Thank you for contacting the City of Sammamish regarding the current Shoreline Substantial Development Permit Application for East Lake Sammamish Trail Segment 2B (SSDP2016-00415).

60% South segment B Lake Sammamish trail plan questions and comments 1/23/2017

Re: Comments re East Lake Sammamish Trail 60% Plan

6) Correction to the Tree Preservation plan that SE 26th is a private road

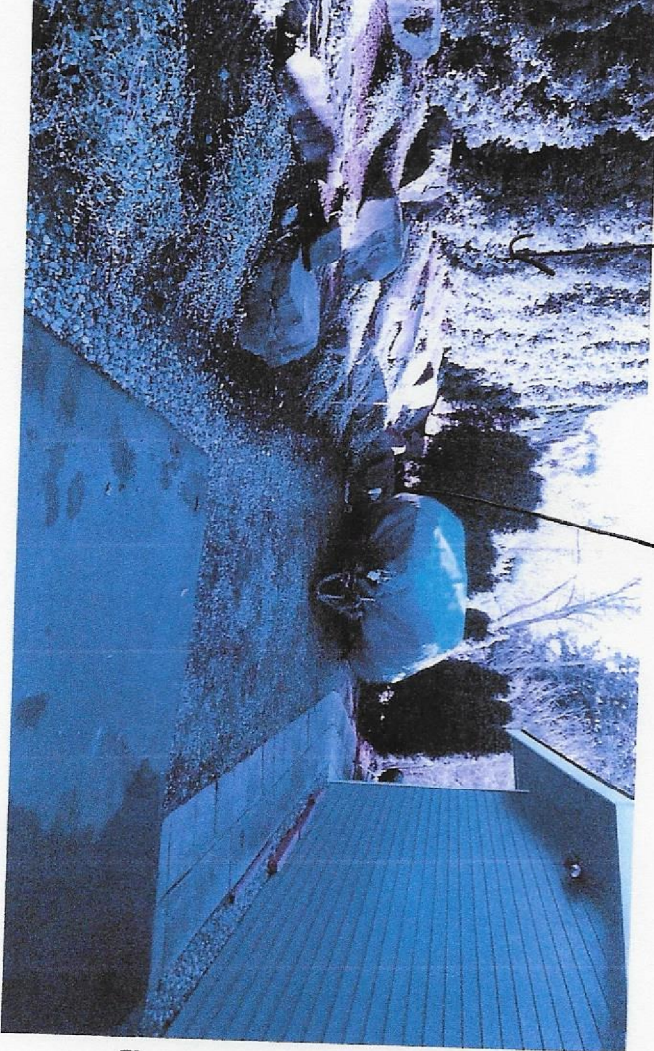
On the tree preservation plan, it notes SE 26th (Driveway 5) as a public driveway. On the 60% plans it is correctly marked as private. SE 26th is a private road and is not to be used for construction or trial access.

Request: We would like the tree preservation plan to correctly state that it is private not public.
